Georgia Power Company  
230 Peachtree Street  
Post Office Box 4545  
Atlanta, Georgia 30302  
Telephone 404 522-6060

August 13, 1980

I&E Bulletin 80-17

The following information is furnished in regard to I&E Bulletin 80-17 Supplement 1 Item A.1:

SOUTH SIDE

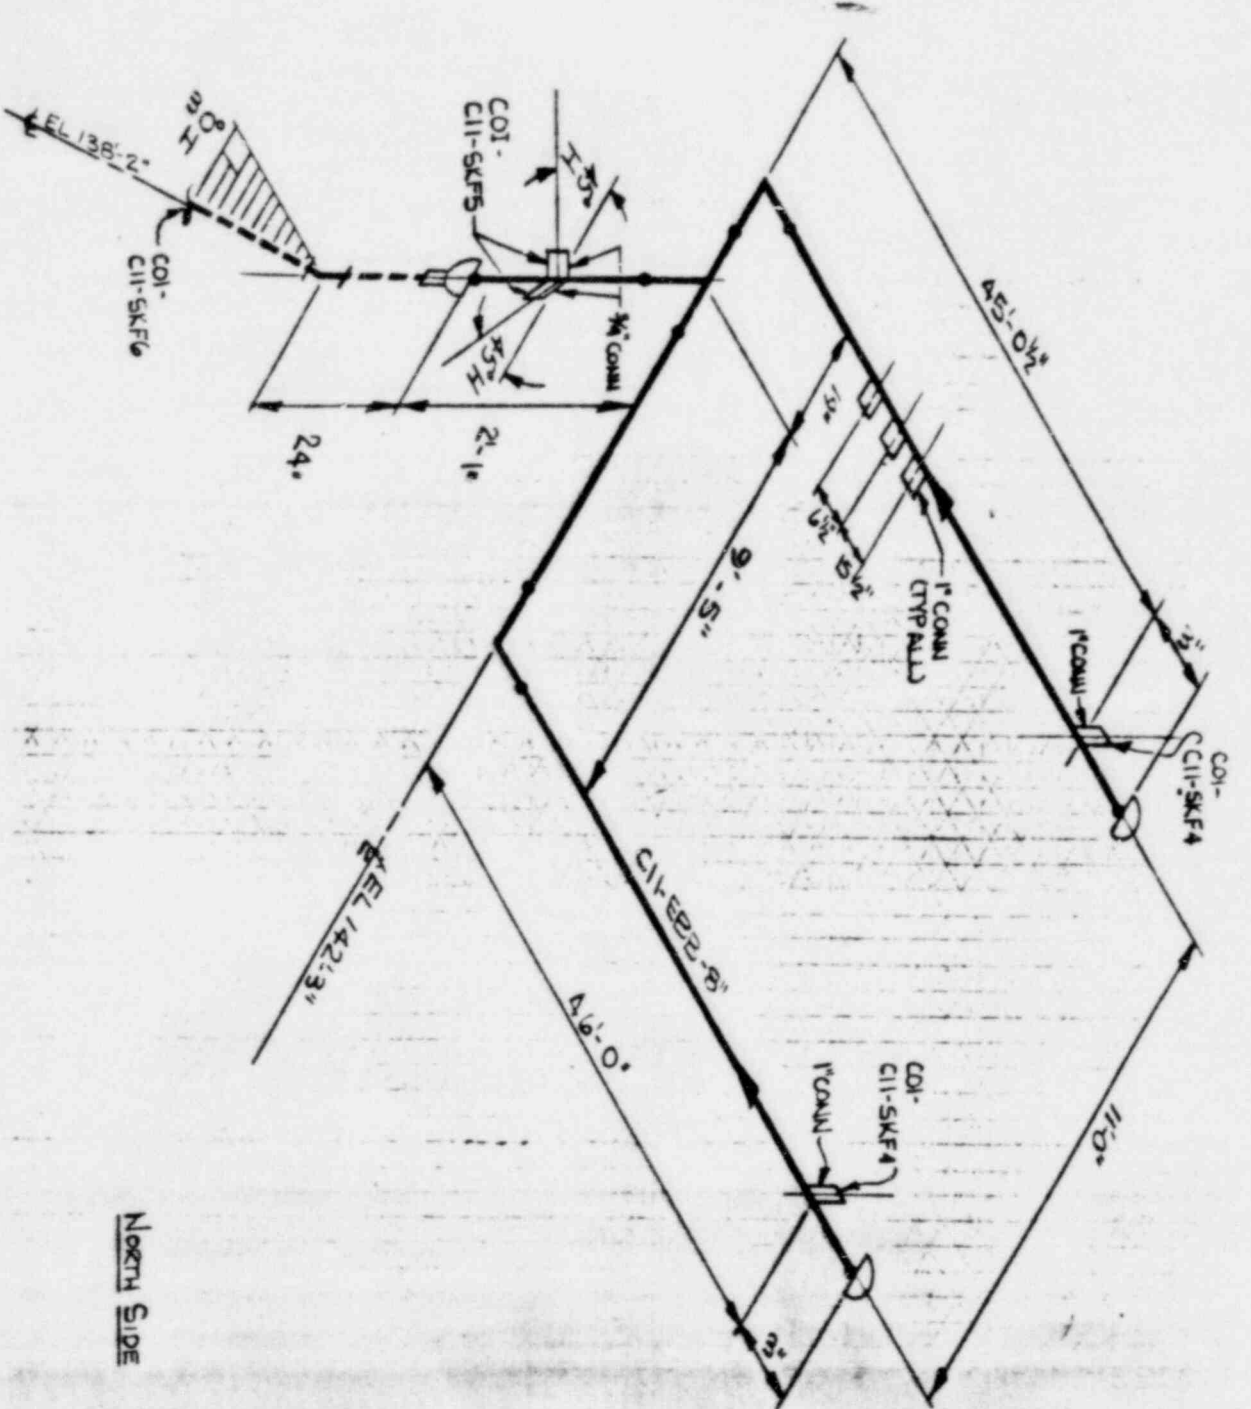
1. Hatch Unit 1 South side header (sketch C11-SK-1) has a low point at the southwest corner. The northwest corner is 1 3/8" higher than the southwest corner.
2. Some sections of the vent and drain lines (2" diameter and less) have a slope less than the specified 1/8" per foot.

1. The design drawings for the south side scram discharge header require that the NW and SW corners be at the same level. Since the drain from the south side header is at the northwest corner, the as-built slope in the line results in a low point in the header. However, it should be noted that there is a large margin between the required and available scram discharge volumes.
2. As-built Hatch Unit 2 isometrics 2T45-F183 (vent F010B discharge), 2T45-F184 (vent discharge from F010A) and 2T45-F197 (drain F001 discharge) in certain areas show that the piping slopes are less than the 1/8"/ft. specified. In addition the slope of piping downstream of Hatch Unit 1 drain valve F011 could not be measured. However, it has been verified that the piping slopes in the proper direction and that there are no loop seals.
